ADDENDUM NO. 1

**NIMITZ HIGHWAY AND ALA MOANA BOULEVARD RESURFACING,
SAND ISLAND ACCESS ROAD TO VICINITY OF PIIKOI STREET**

FEDERAL AID PROJECT NO. NH-092-1(030)

The following amendments shall be made to the Bid Documents:

FED. ROAD DIST. NO.	STATE	FED. AID PROJ. NO.	FISCAL YEAR	SHEET NO.	TOTAL SHEETS
HAWAII	HAW.	NH-092-1(030)	2021	ADD. 22	50

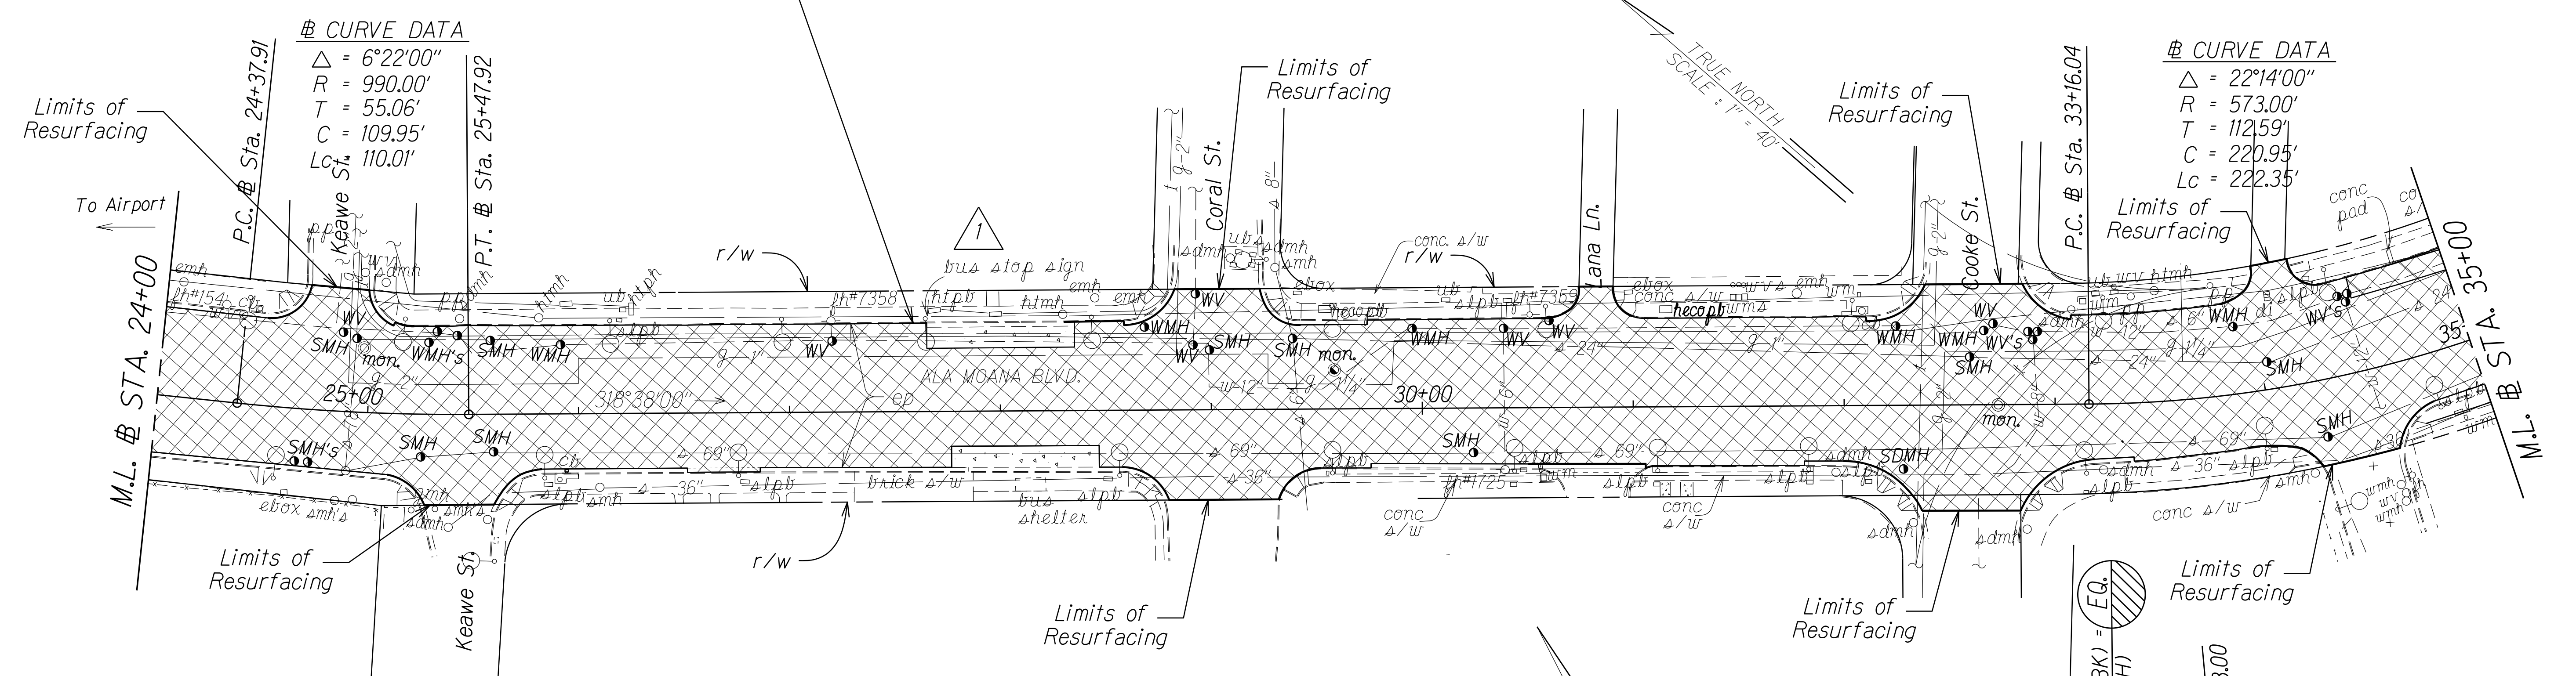
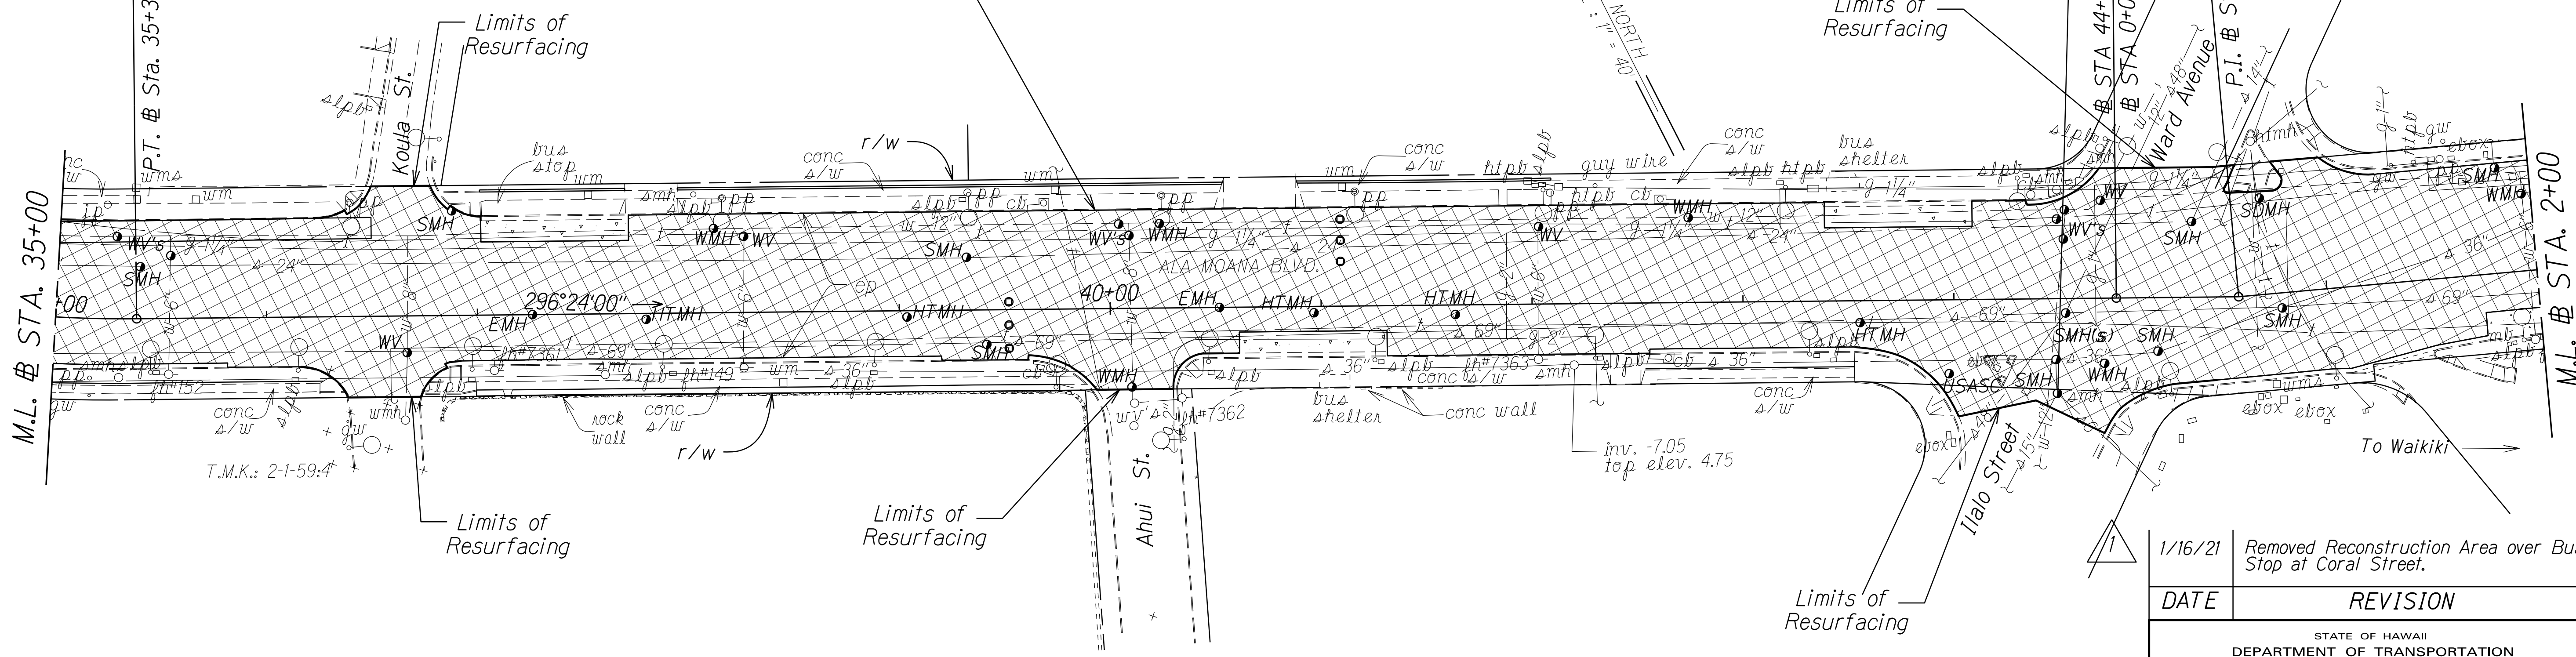
DATE	REVISION
1/16/21	Removed Reconstruction Area over Bus Stop at Coral Street.

20. Please clarify if there is work at the concrete bus pad at the westbound corner of Coral St. and Ala Moana Blvd. Intersection.

There is no concrete work for bus pads on this project and Sheet 22 incorrectly shows reconstruction hatching over the mentioned bus pad. Refer to Sheet ADD. 22.

TYPICAL DETAIL FOR CONSTRUCTION SIGNS
 ON MULTILANE DIVIDED LOW SPEED HIGHWAY

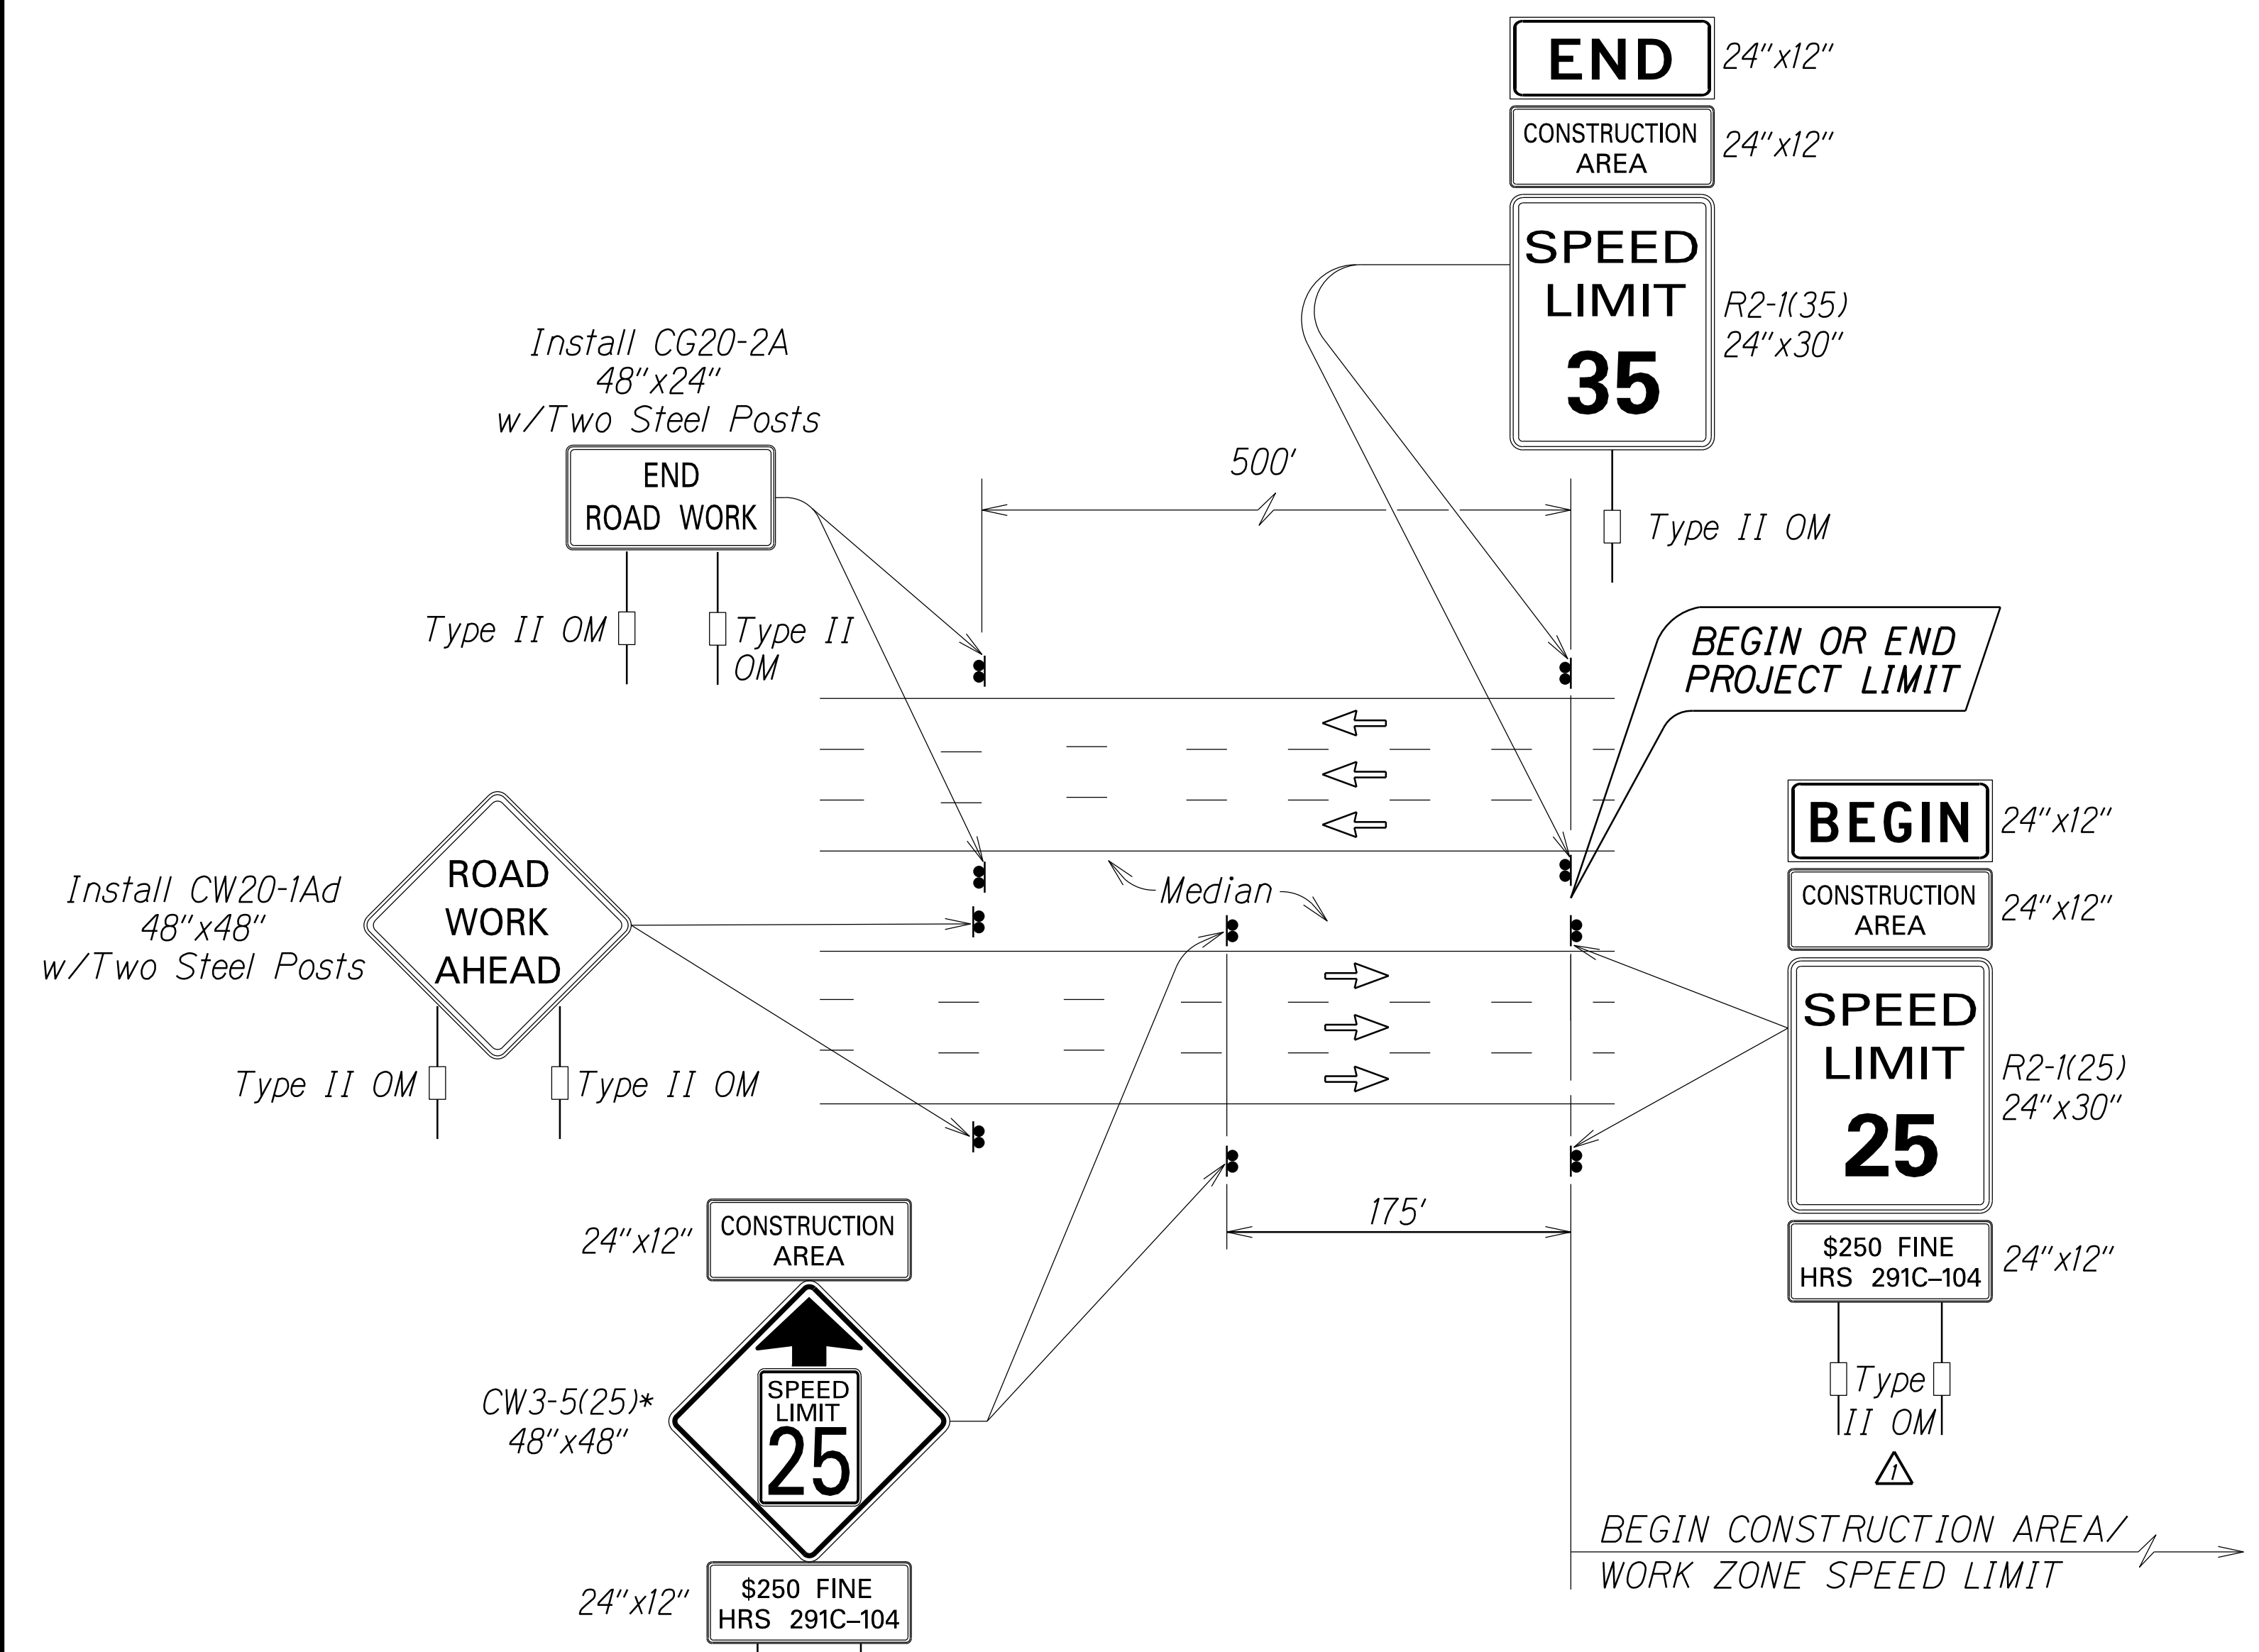
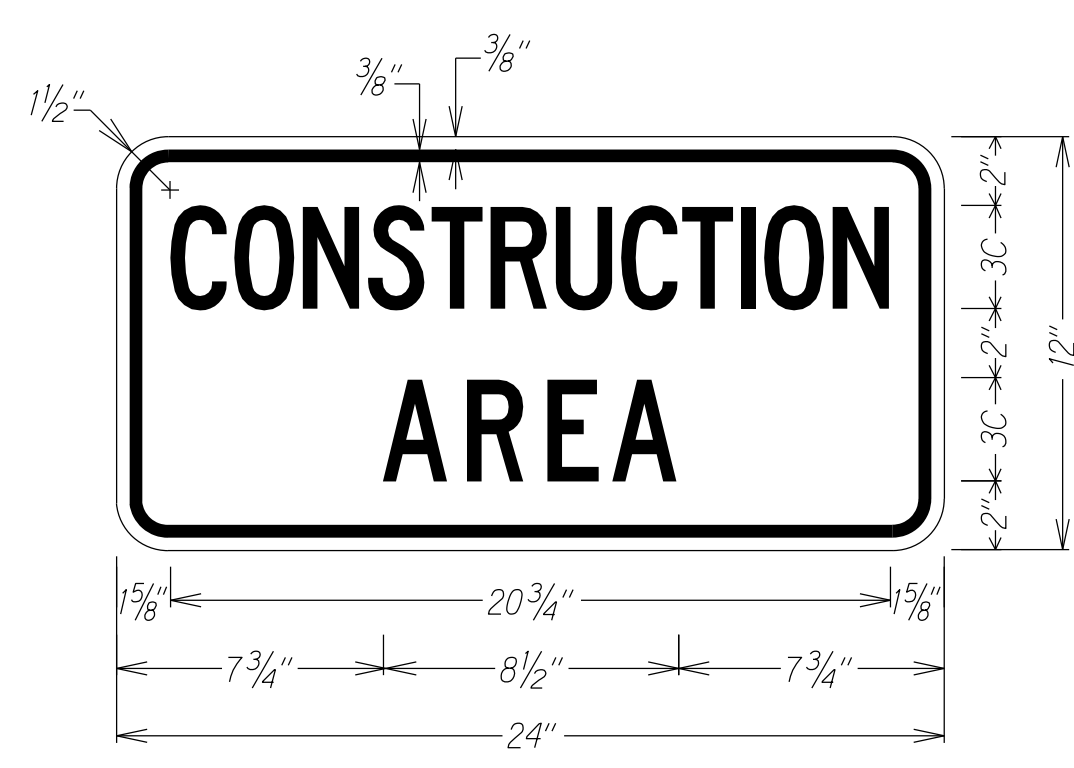
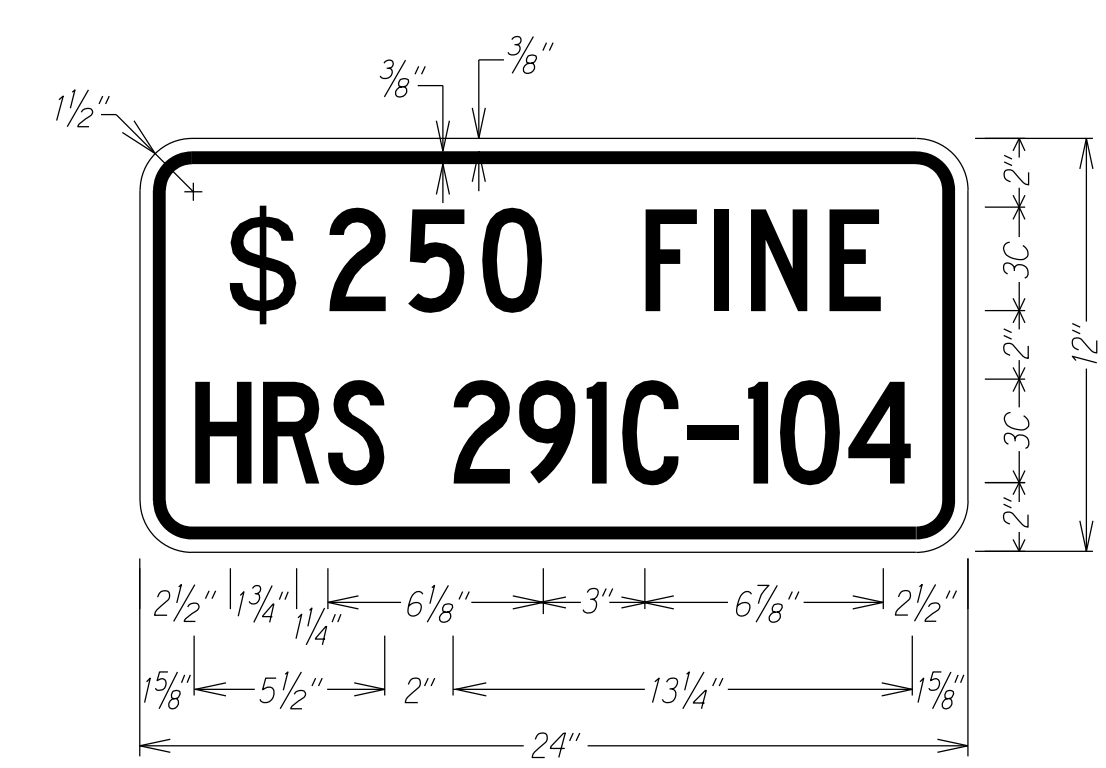
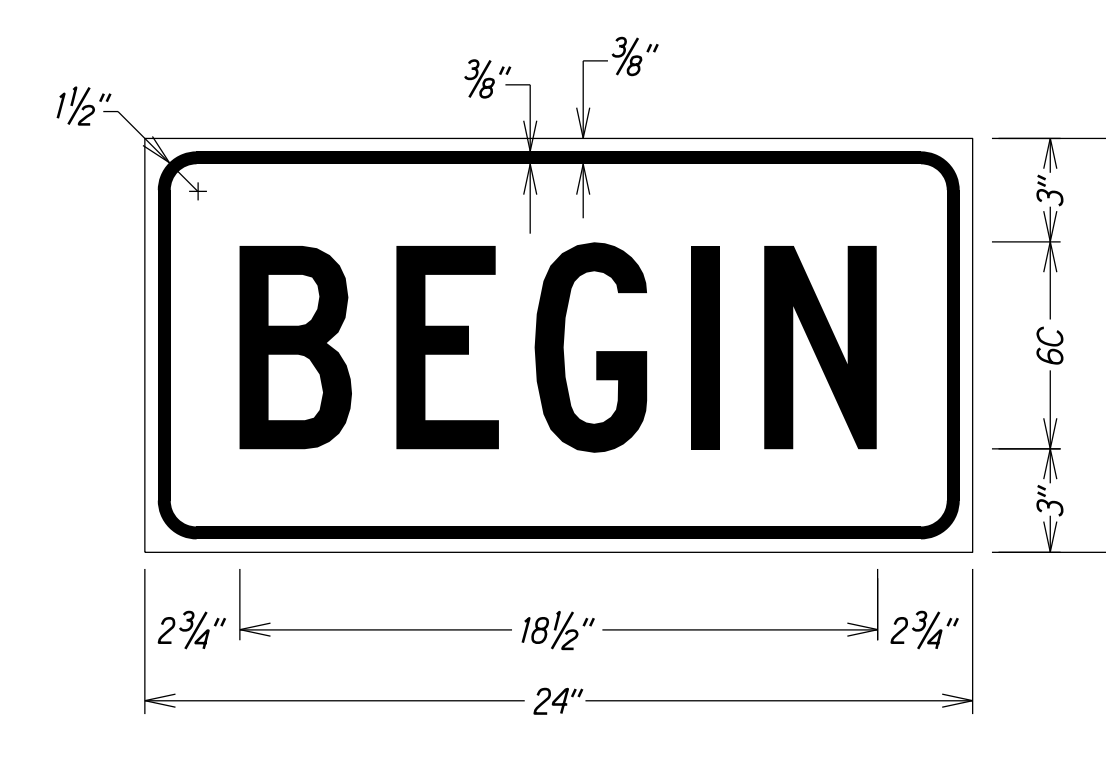
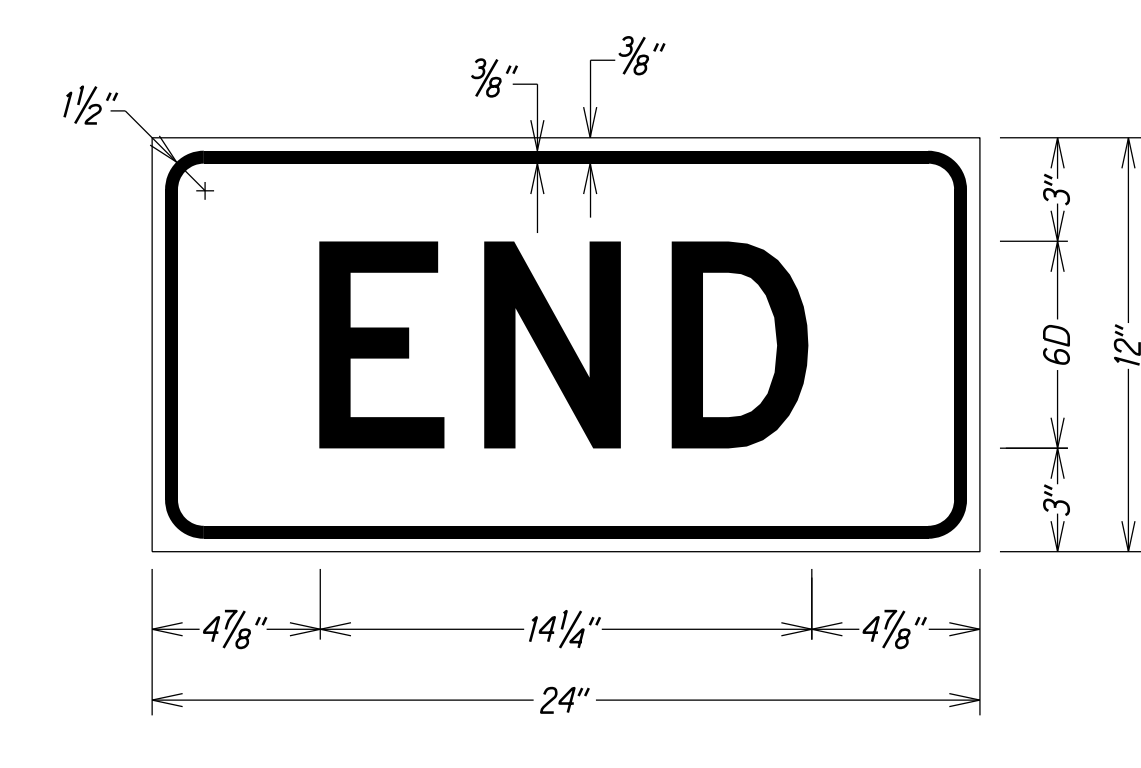
2/11/21	Change sign assemblies to show two posts.
DATE	REVISION
STATE OF HAWAII DEPARTMENT OF TRANSPORTATION HIGHWAYS DIVISION	
LOW SPEED DIVIDED HIGHWAY	
WORK ZONE SIGNING PLAN, NOTES & DETAILS	
NIMITZ HIGHWAY & ALA MOANA BOULEVARD RESURFACING Sand Island Access Rd. to Vic of Piikoi St. Federal-Aid Project No. NH-092-1(030)	
Scale: As Shown	Date: August, 2020
SHEET No. T3 OF 20 SHEETS

9. On Sheet 33 can you please clarify the size of sign for - Construction Area/Speed Limit 25 Ahead/\$250 Fine Sign Set on Post - Either the size of Speed Limit 25 Ahead sign needs to be reduced to 30"x30" or 36"x36" to use one post, or two posts need to be used. Can this be clarified?

All the sign(s) shown on Sht. 33 and 34 with total sign areas bigger than 10 s.f. should have two (2) sign support posts per Standard Plan TE-03B. We will revise the two drawings accordingly. Refer to Sheets ADD. 33 and ADD. 34.
